Title & Document Type: 10811A/B Quartz Crystal Oscillator Operating and

Manual Part Number: 10811-90002

CHANGE DATE: April 26, 1990

The information in this supplement is provided to correct manual errors and to adapt the manual to instruments containing changes after the manual print date.

Figure 2-3. 10811A Supply and Output Connections

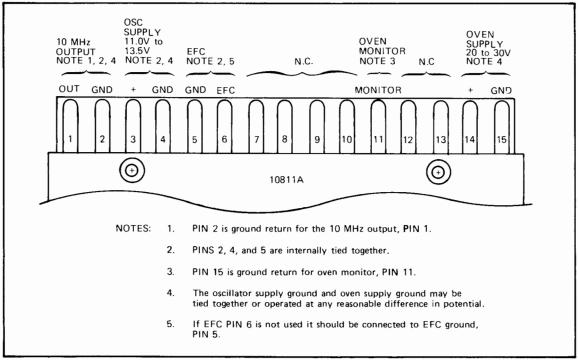
Figure 2-3. 10811A Supply and Oven Connections: >Add to Note 2: "...and the outer housing".

Figure 2-4. 10811B Supply and Output Connections

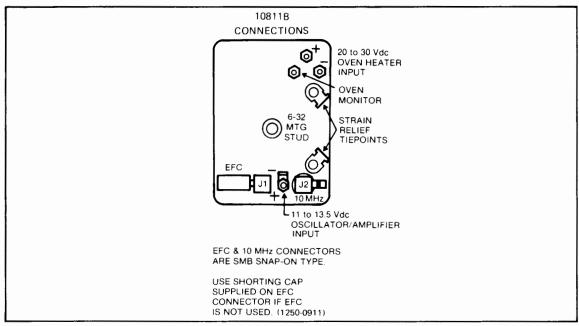
Figure 2-4. 10811B Supply and Oven Connections: >Change mounting stud screw size from 6-32 to 4-40, in center of the drawing.

Figure 5-2. 10811A Amplitude Adjustment Set-up

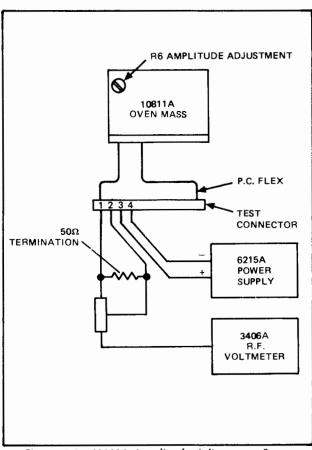
All Serials Figure 5-2. 10811A Amplitude Adjustment Set-up: >Change the figure to match the following figure:

>Change the word "Micon" to "SMB".

Figure 5-3. 10811B Amplitude Adjustment Set-up

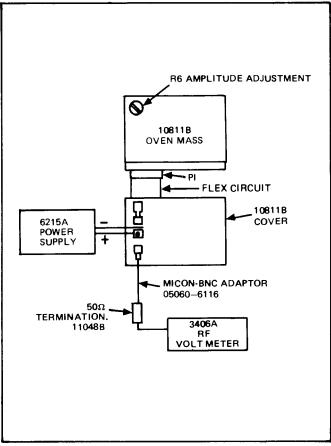
Figure 5-3. 10811B Amplitude Adjustment Set-up: >Change the adapter description from "Micon-BNC" to "SMB-BNC".

Figure 8-13a. OSCILLATOR ASSEMBLY

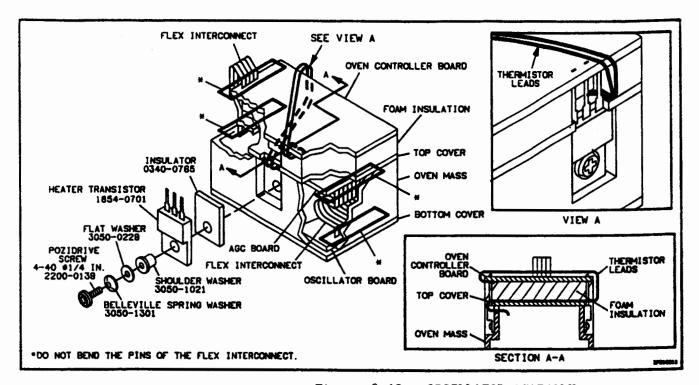
d. Thermistor Lead Routing. When assembling oven controller board into oven mass, thermistor leads should be routed between oven mass and foam wafer as shown in figure 8-13a, section A-A.

This placement of thermistor leads improves frequencyversus-temperature stability. When oven controller

board, foam wafer, and oven mass are assembled they should appear as in view A of figure 8-13a.

e. Oven heater transistors Q7 and Q8: Install each transistor as shown in Figure 8-13a. Torque to 4 lbf.in (.452 N.m.) using hand torque screwdriver.

# Page 8-25. Figure 8-15. 10811A/B OSCILLATOR COMPONENT LOCATOR/SCHEMATIC DIAGRAM:

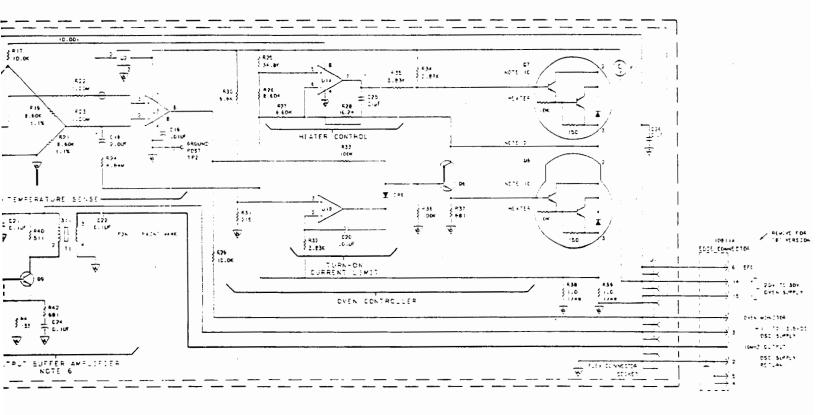
>Change 10811-60001 for 10811A to 10811-60115, series 2244. >Add Pin 1 callout to edge connector photo. Pin 1 is end pin nearest W3.

>Add W3 reference designator to 7-COND Flat Ribbon Assy between Oven Controller and Edge Connector.

>Replace 10811-60015 (Series 2244) component locator/schematic diagram with new 10811-60004 (Date Code 88471) component locator and schematic diagram supplied in these manual changes.
